**MONTGOMERY COUNTY PLANNING BOARD**  
THE MARYLAND-NATIONAL CAPITAL PARK AND PLANNING COMMISSION

MCPB No. 19-108  
Sketch Plan No. 320190100  
8015 Old Georgetown Rd  
Date of Hearing: September 5, 2019

**RESOLUTION**

**PROJECT:** 8015 Old Georgetown Road  
Site Plan No. 820200130

FIRE ACCESS PLAN

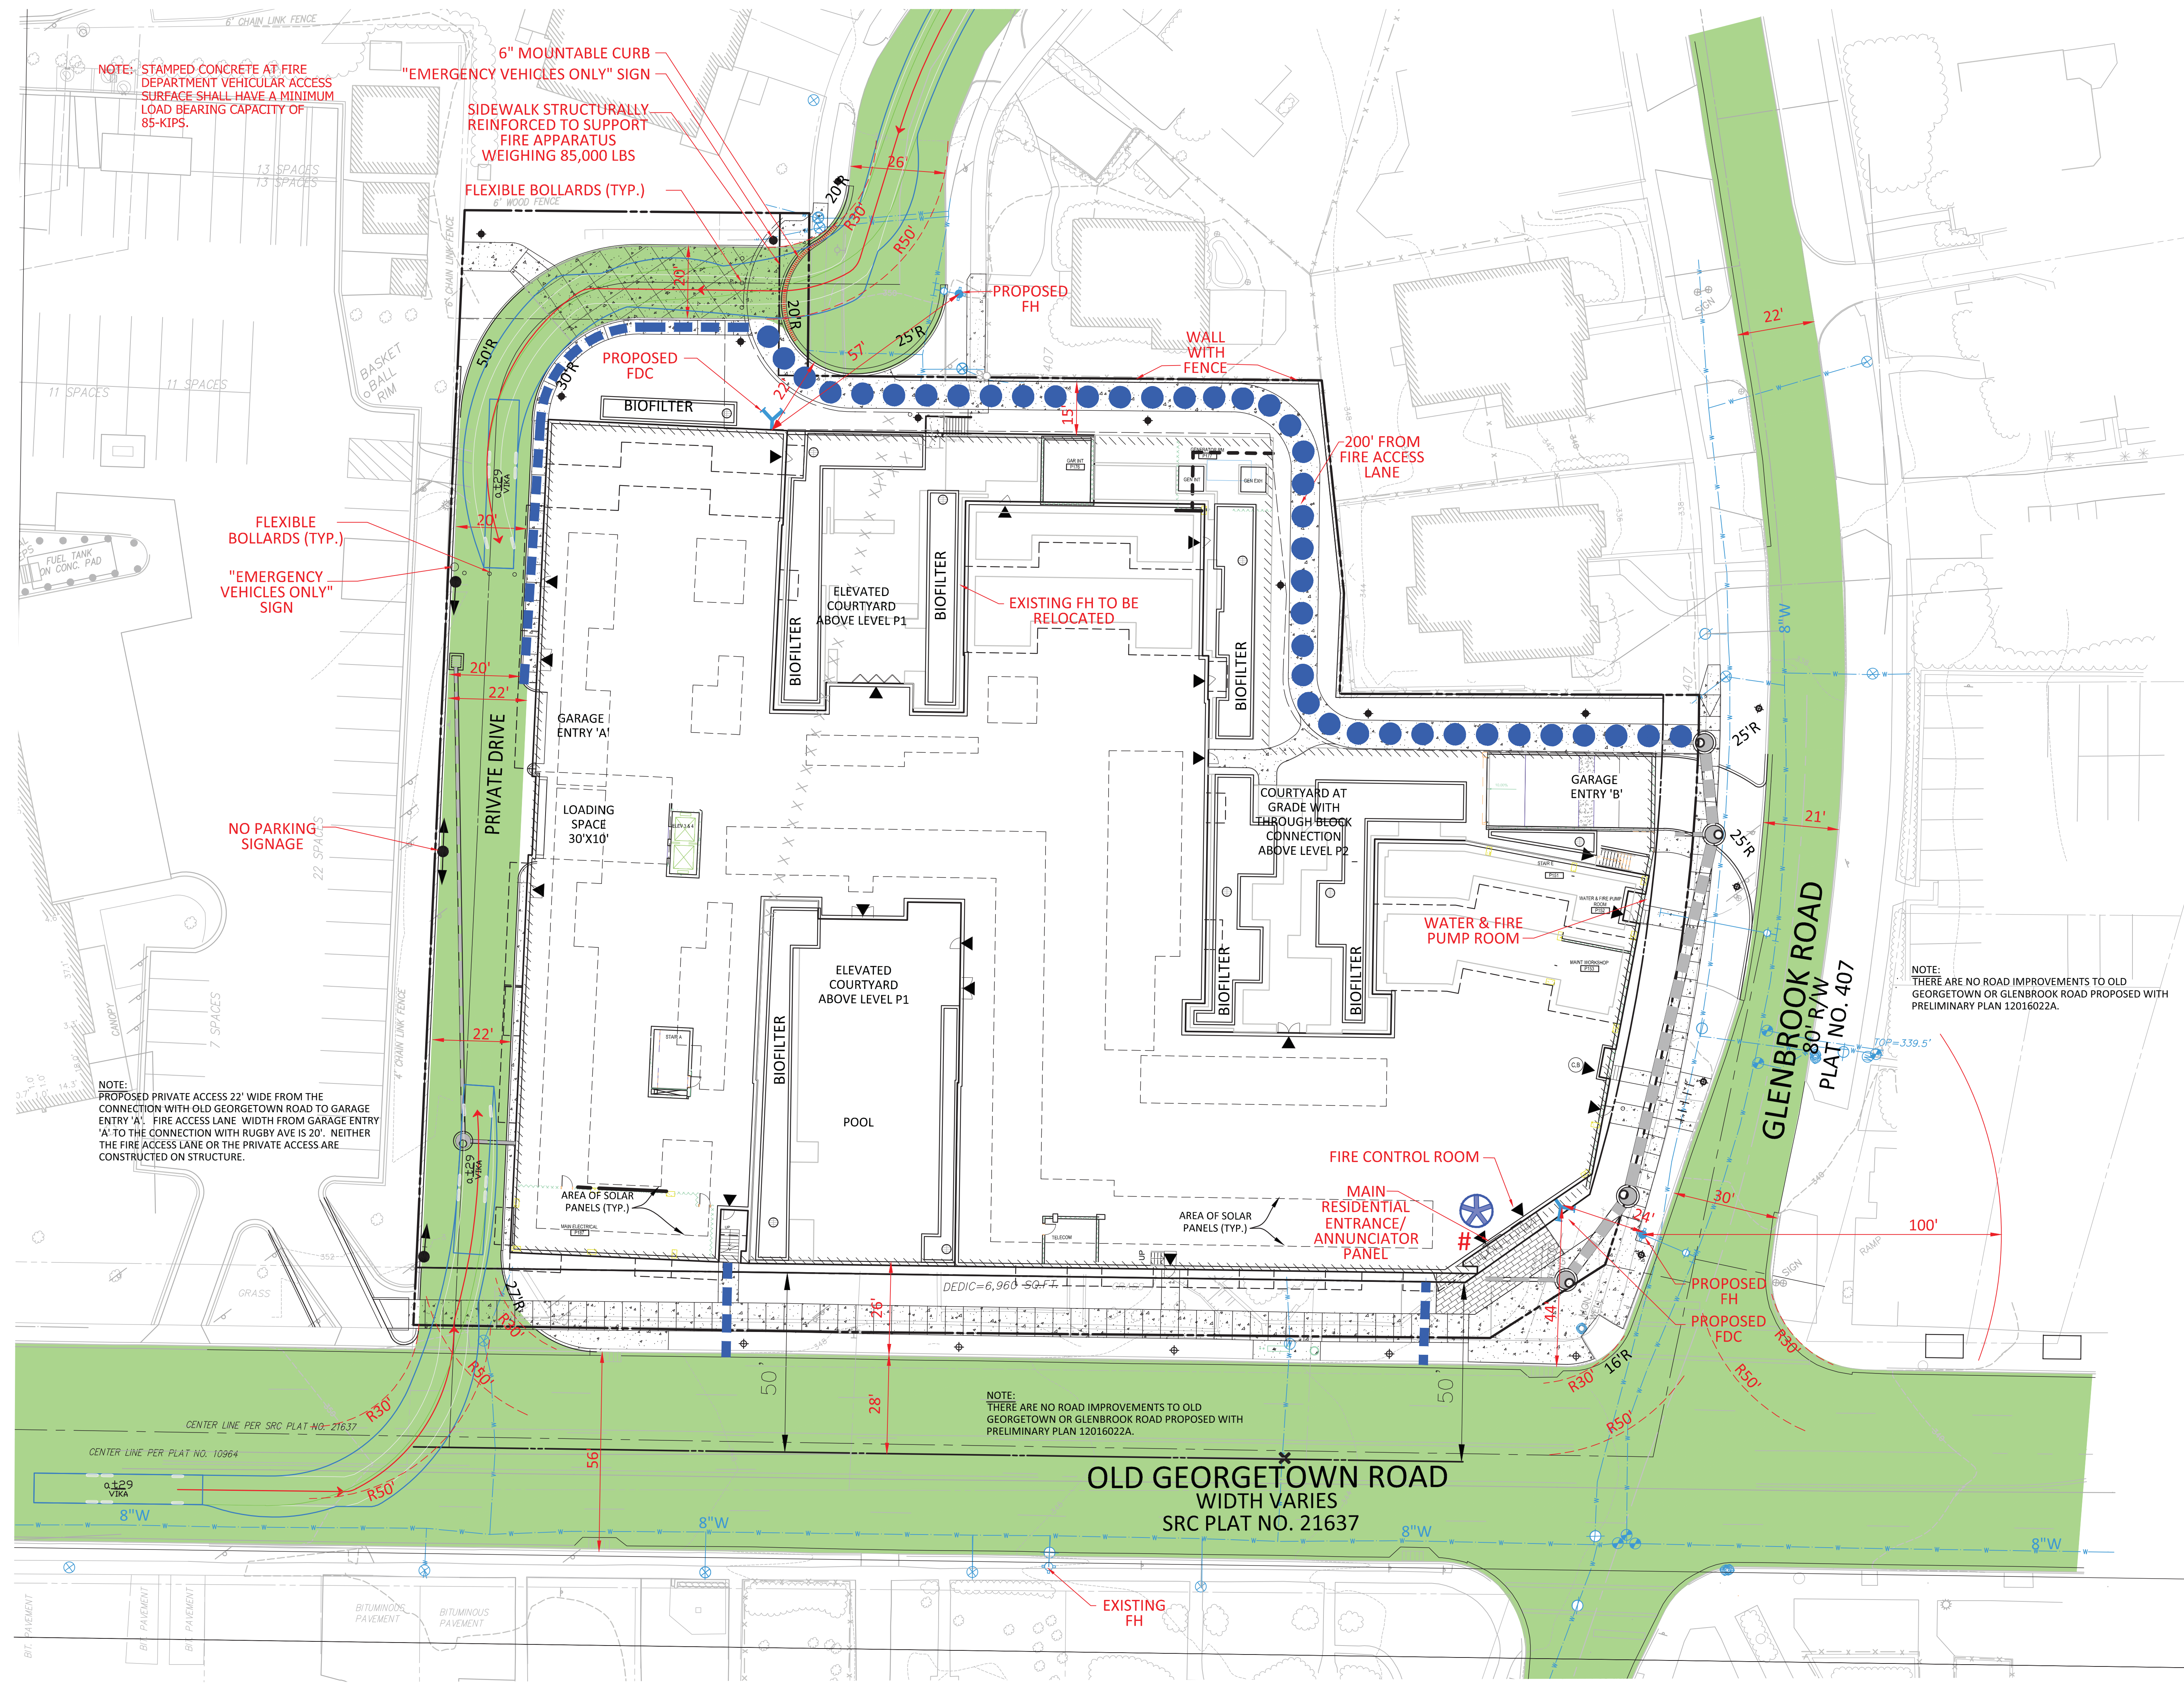
FIRE CODE ENFORCEMENT  
Fire Department Access Review  
Review based only upon information contained on this plan. Does not cover unsatisfactory layout resulting from omissions, errors or failure to clearly indicate conditions on this plan. Correction of such unsatisfactory layout to afford required access will be required if found upon inspection after installation.  
BY: SML\* PM: 43 DATE: 5/13/2020
